## Staff Report for PLSUP-2603-0004

Applicant is requesting a Special Use Permit to replace electrical components related to the water pump station on the site.

**WATER PUMP STATION 1  
IMPROVEMENTS**  
DULUTH, MINNESOTA

**GENERAL LAYOUT  
STATION 1**

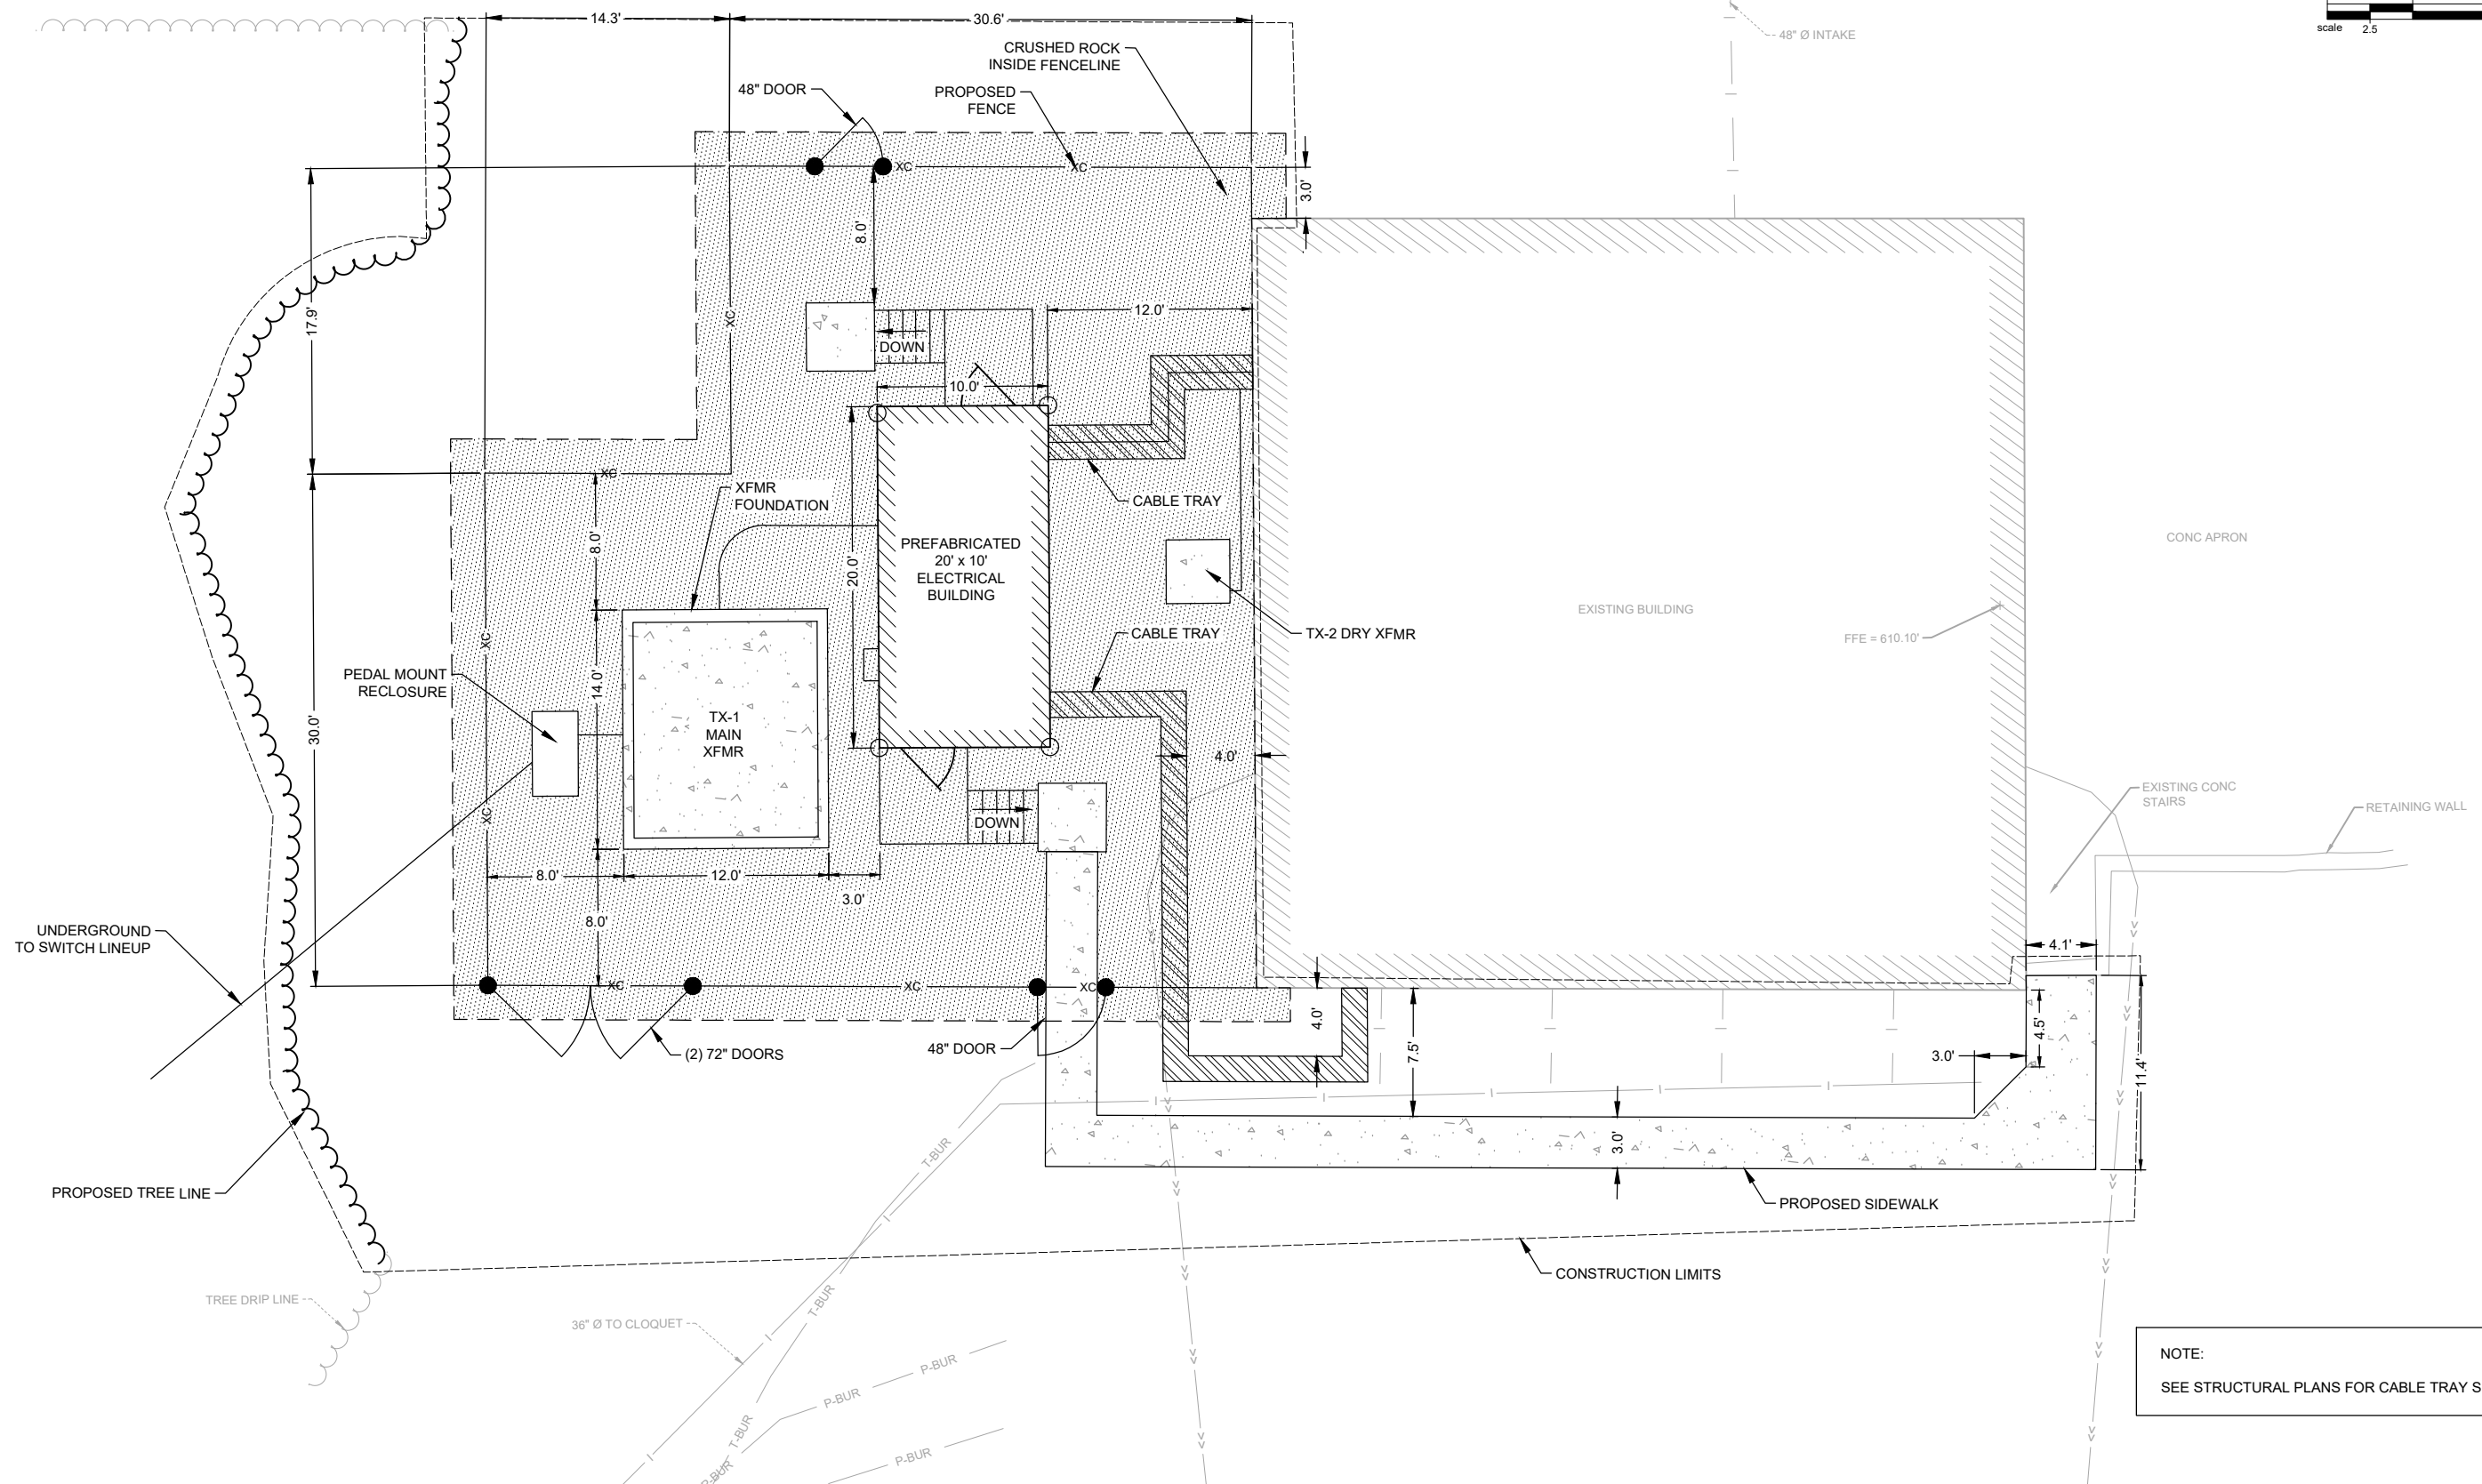
Looks like they are taking some trees. They also appear to be impacting a dune. I wonder if there is any dune grass on it. That grass is a protected species.

Anyway we can ask for a reconfiguration where the TX-1 MAIN XFMR is rotated to not impact the pine and the dune? Let me know how I can help.

**TREE LOCATIONS  
 STATION 1  
 DULUTH, MINNESOTA**

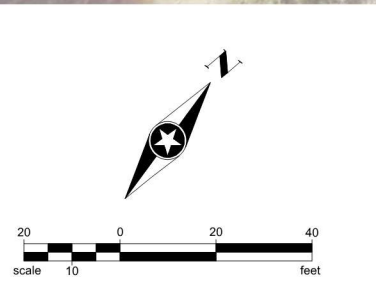
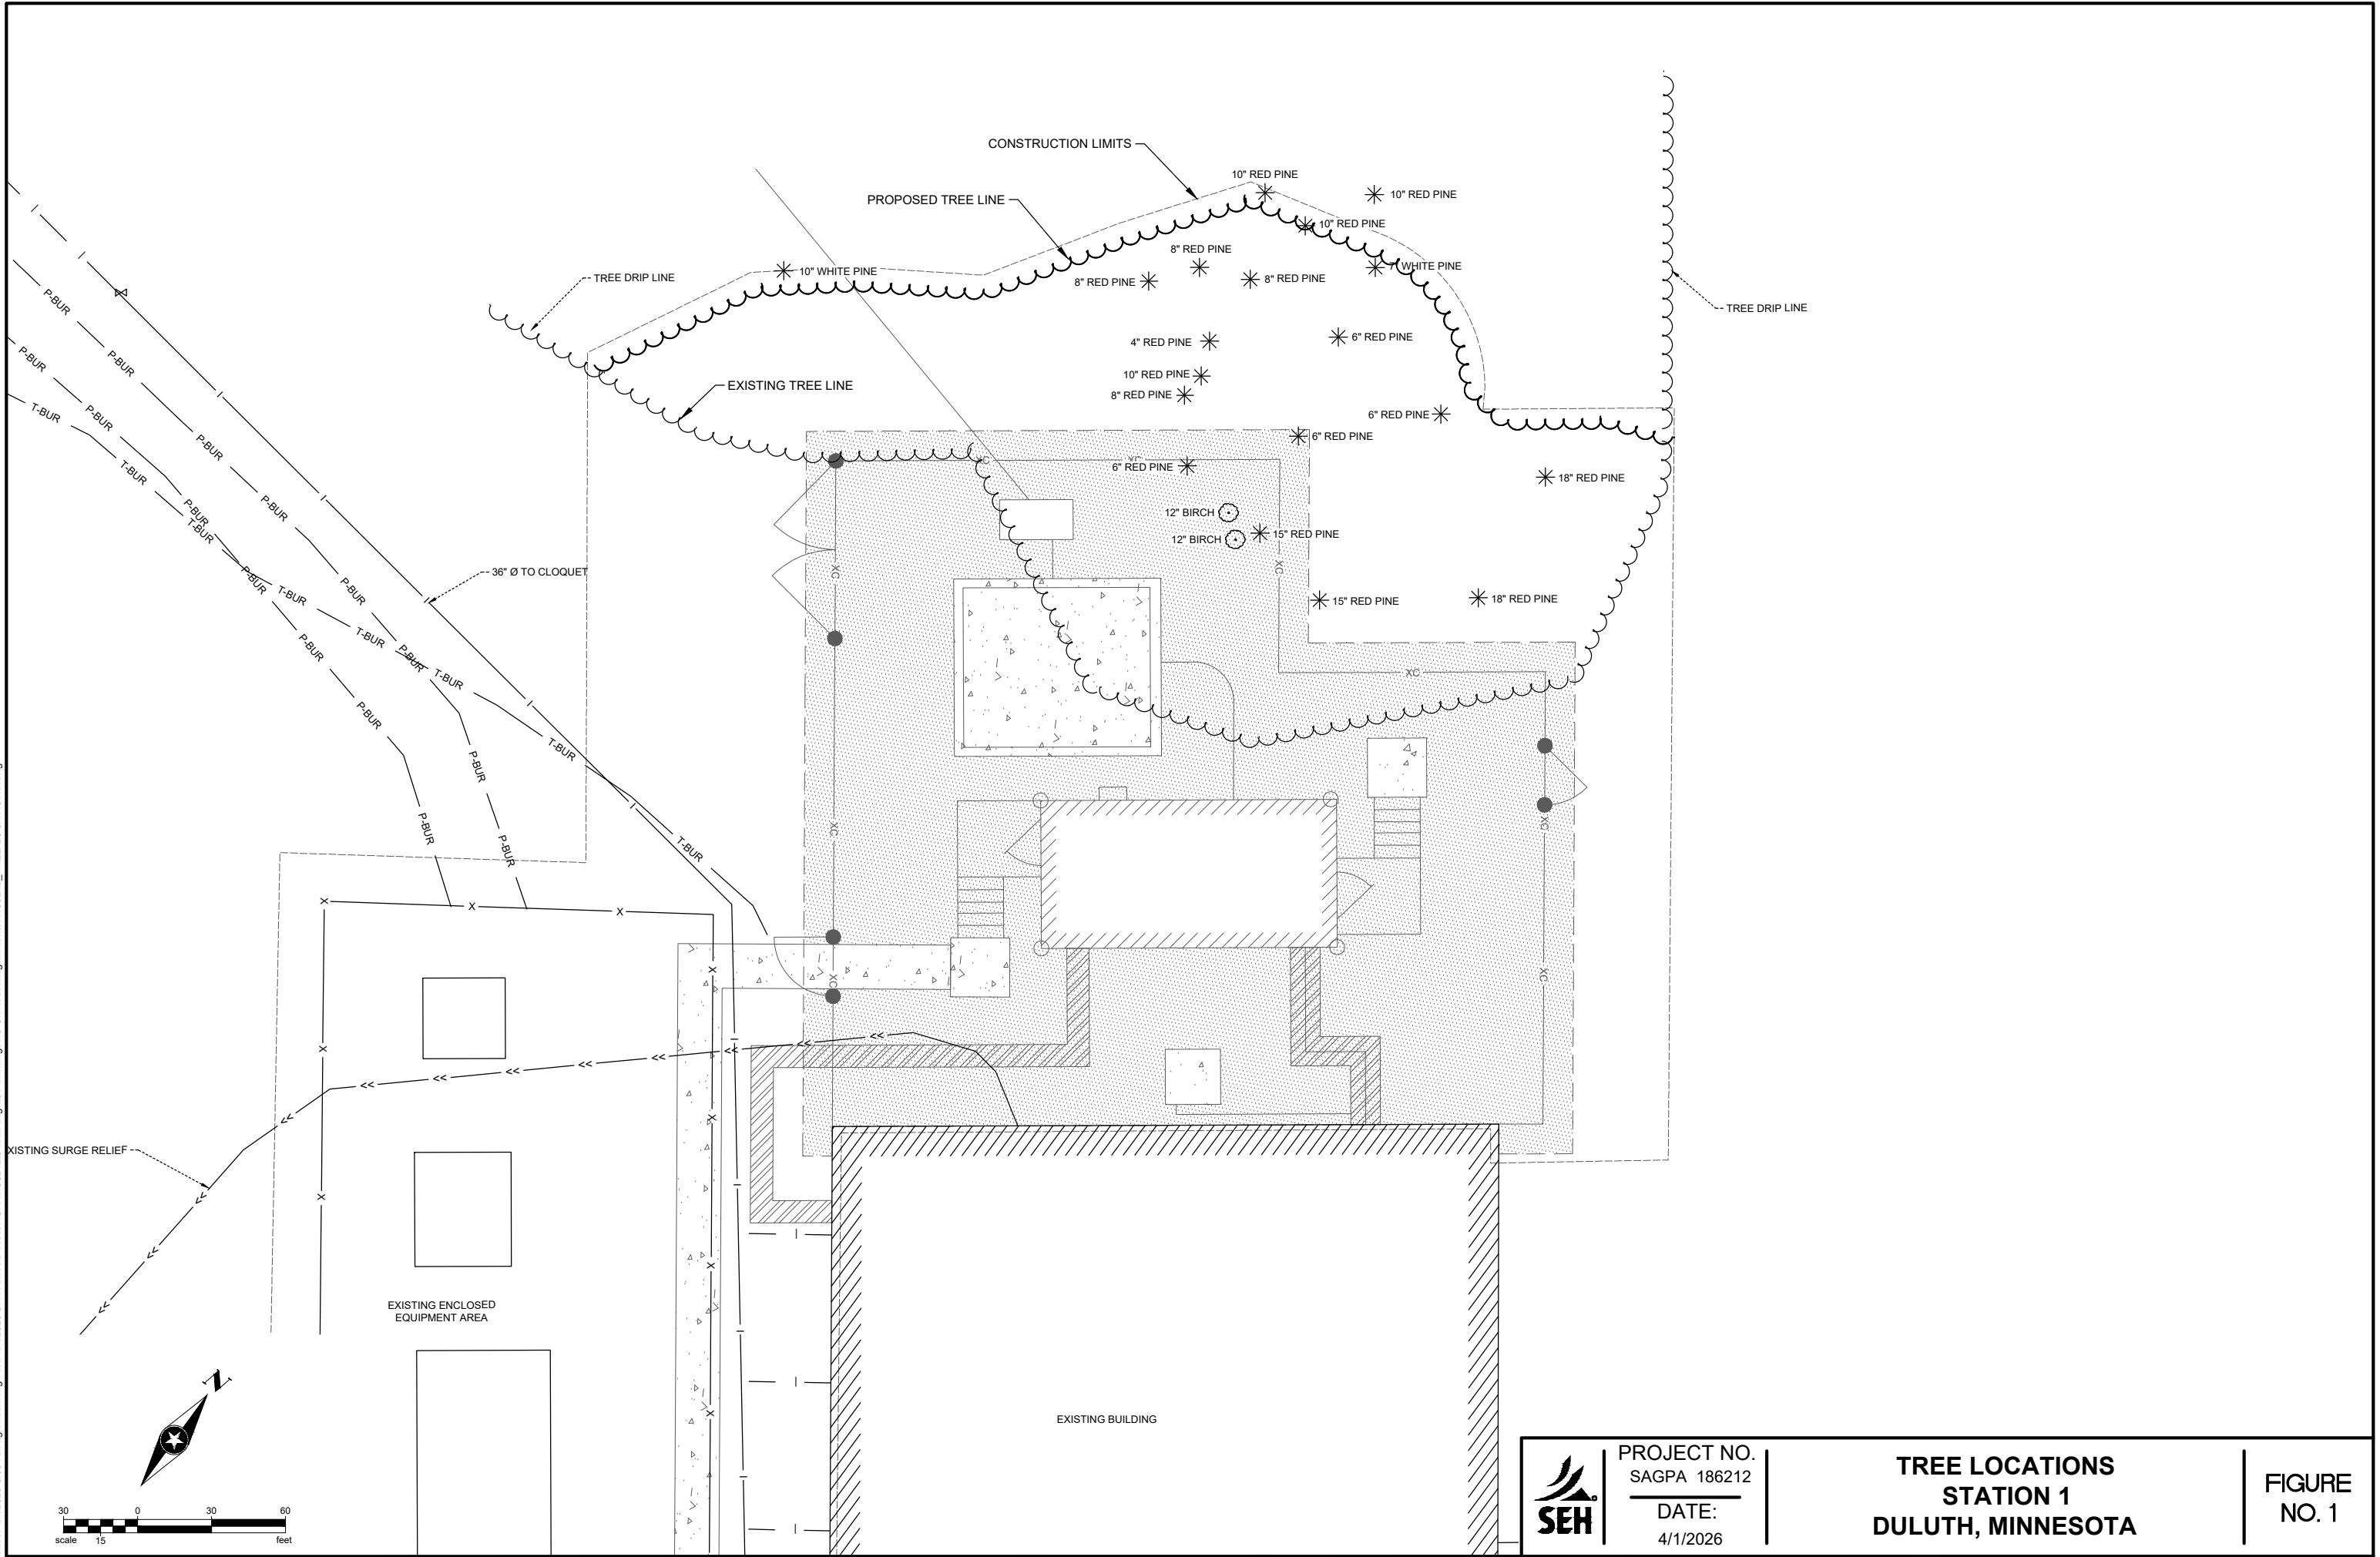
As for the landscape plan the species must be native and consistent with the Native Plant Communities regime FDN32b Red Pine – White Pine Woodland (Minnesota Point). Norway spruce is a non-native and a species we do not want down there. Some acceptable species would be Prickly or smooth wild rose (*Rosa acicularis/blanda* group), pin cherry (*Prunus pensylvanica*), bush honeysuckle to name a few. Here is a link to help.

- Plantings: We oppose any plantings of non-native species such as Norway spruce. Instead, we recommend native species such as white spruce (*Picea glauca*) or red or white pine (*Pinus resinosa* or *strobus*). Highbush cranberry, while native, is closely related to its non-native counterpart. They can be hard to tell apart, hybridize, and European highbush cranberry has been inadvertently sold as a native species. We recommend instead to focus on native species already found on the point such as pin or sand cherry (*Prunus pensylvanica* or *pumila*) or Amelanchier species. A plant list of known species found on [Minnesota Point Pine Forest SNA](#) can be found [here](#).
